iFly Novi JSP 18-49

Consideration at the request of SkyGroup investments, LLC for JSP 18-49 iFly Novi for approval of a Section 9 waiver. The applicant is proposing a 6,713 square foot indoor recreational facility; popularly known as iFly that provides an indoor skydiving experience. The applicant is requesting a revised Section 9 waiver for changing the color of flat metal panels.

FACADE REVIEW
Dated 03-08-19

Re: **FACADE ORDINANCE REVIEW (Final Site Plan)**
iFLY at Adell Center, JSP18-49
Façade Region: 1, Zoning District: Rezoning to TC-1

PREVIOUSLY APPROVED BUILDING ELEVATIONS

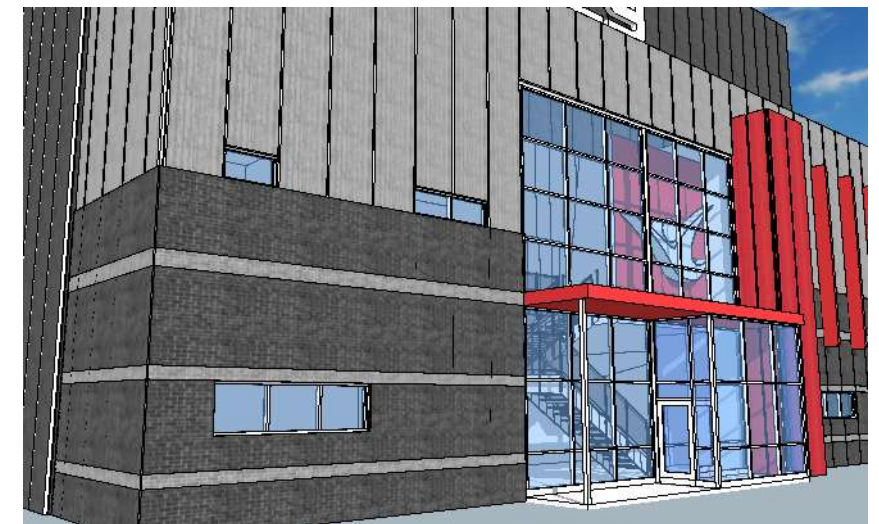
FACADE MATERIAL CALCULATIONS:

RETURN AIR TOWER (65') HEIGHT IS A METAL PANEL CLADDING SYSTEM. MASONRY IS NOT STRUCTURALLY SAFE TO INSTALL DUE TO THE VIBRATIONS CREATED BY THE TUNNEL SYSTEM HOUSED BY THE TOWER STRUCTURE.

THE BUILDING FACADE (40') IS CONSTRUCTED WITH A 20' WAINSCOT OF BRICK (= 50% OF GROSS AREA) AND A 20' METAL PANEL ABOVE THE WAINSCOT.
